Project Description / Description de projet		
Gate Replacement and Paving/Remplacement et pavage des portes		
Solicitation No./N° de sollicitation	Project No./N° de projet	W.O. No./N° d'ordre de travail
19-58077	5778	A1-011344-10-01
Departmental Representative / représentant ministériel		Date
Alain Leroux		January 16, 2020
<p>Notice:</p> <p>This addendum shall form part of the tender documents and all conditions shall apply and be read in conjunction with the original plans and specifications.</p>		<p>Nota:</p> <p>Cet addenda fait partie intégrale des dossiers d'appel; toutes les conditions énoncées doivent être lues et appliquées en conjonction avec les plans et les devis originaux.</p>

PROJECT NRC – Gate Replacement & Paving – Sandy Cove	PROJECT NO. NRC: 5778 MCA: 17-569
DESCRIPTION Addendum 1 – Issued for Tender – Clarifications & Changes	DATE Jan 14, 2020

ACCESS CONTROL POST DETAIL

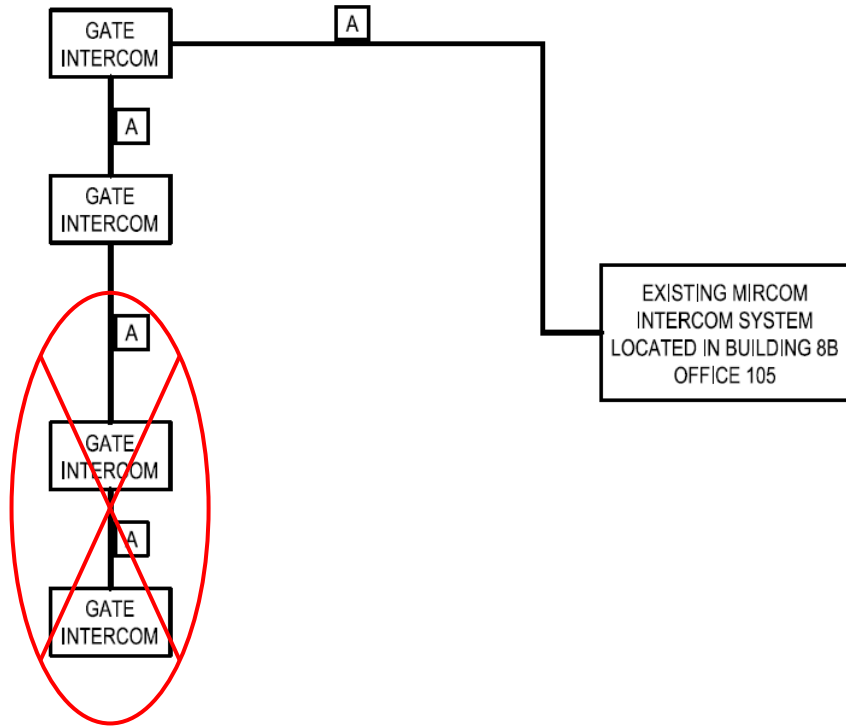
2. Deletion – Reference: Drawing E1/E2

- a. The upper card reader and Mircom intercom on both sides of the gate shall not be provided. Any wiring/hardware associated solely with these deleted readers/intercoms shall also be removed from the project scope.

3. Clarification – Reference: Drawing E1

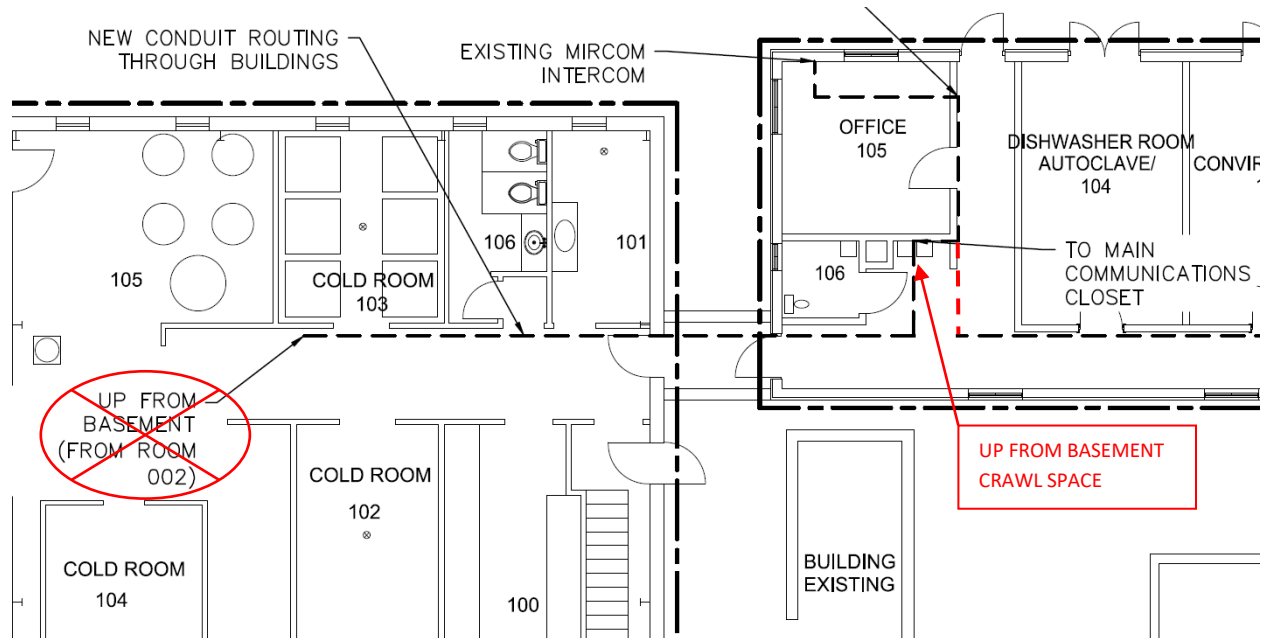
- a. New conduit coming from basement shall feed through the crawl space and penetrate up through to the main floor near the communications closet.
